OFFICIAL NOTICE NO. 97-2016
Project 1

Addendum No. 1

ST211170103 – W. Becher St. – S. 7th St. to S. 10th St. (Pedestrian Crossings)

ST211170104 – W. Oklahoma Ave. at S. 10th St. (Pedestrian Crossing)

ADJUSTING CUC MANHOLE COVERS

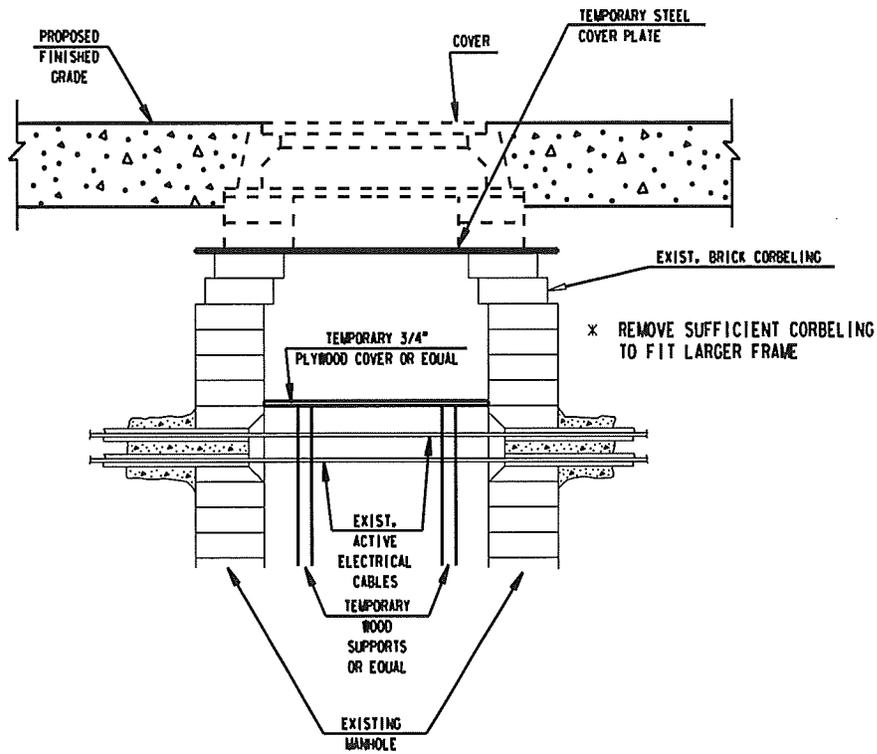
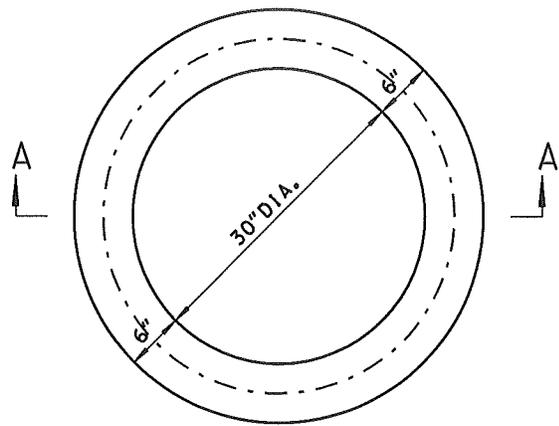
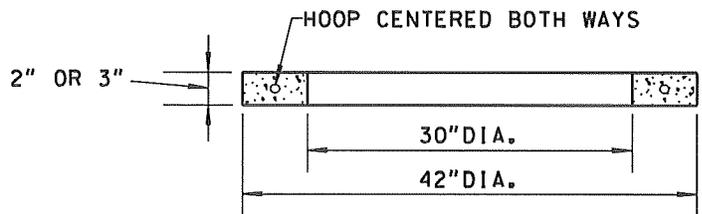
This special provision describes adjusting the existing chimney of the block, pre-cast, or brick round manholes; and furnishing, installing, and removing protection of the cables in the manholes during adjustment and paving operations. Perform work in accordance with the standard specifications, per *Standard Specifications for Sewer & Water Construction in Wisconsin*, as shown on the attached sketch, and as hereinafter specified.

Remove existing chimney to surface of concrete roof slab. If manhole does not have an existing concrete roof slab, remove sufficient chimney as to provide adequate corbel to fit new larger cast iron frame and cover.

Adjust manhole cover to proposed grade using brick or concrete rings as necessary. After paving is complete, remove all wedges and shims. Fill voids with grout. Do not back plaster inside walls. After completion of all paving operations, remove the temporary ¾" plywood cover or equal which was placed over the existing electrical cables in the manhole as mentioned above. Remove all construction debris from the manhole.
